PLC Packet Mk III Data Structure (608 bytes)

This is a firm proposal for the 3rd GenPLC packet structure (Mark III).

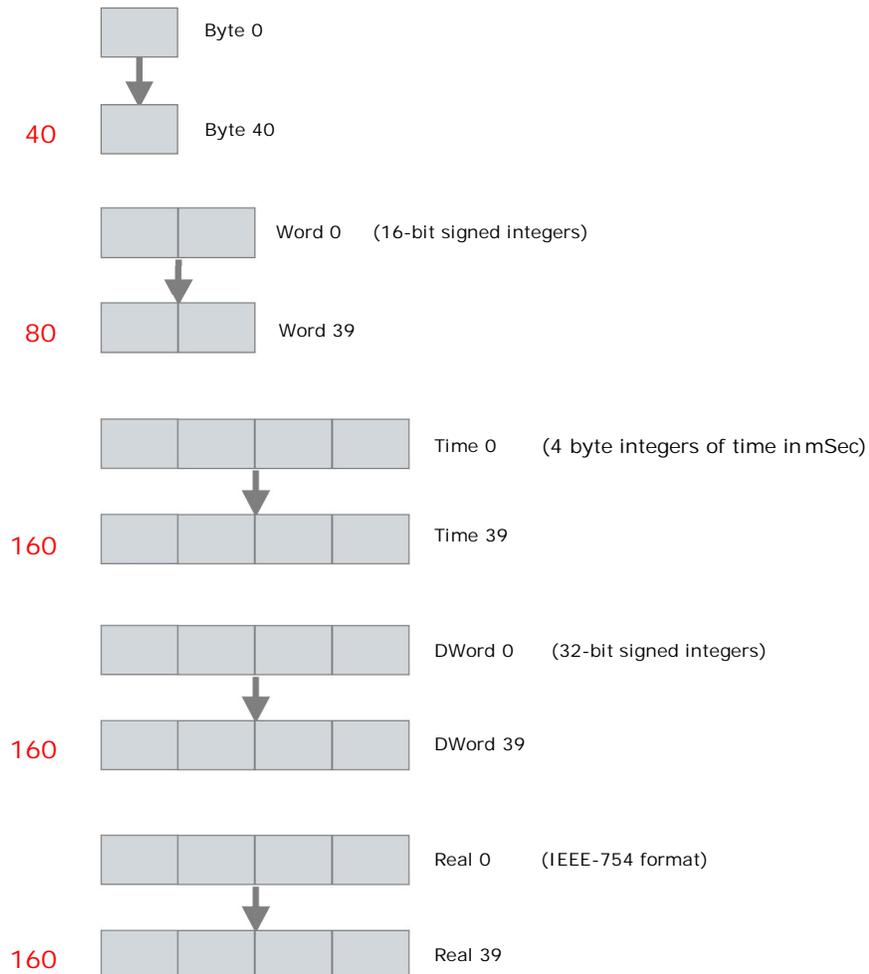
- The SIGS are gone, we read everything into memory, used or not.
- The number of digital bytes has been expanded to 40 bytes.

We expect to implement this new packet structure in all PLC's during the 2012 shutdown. The Safety System computer will be coded in accordance with these proposed changes. It is expected that this structure will "future proof" most, if not all, of the Safety System computer PLC applications.
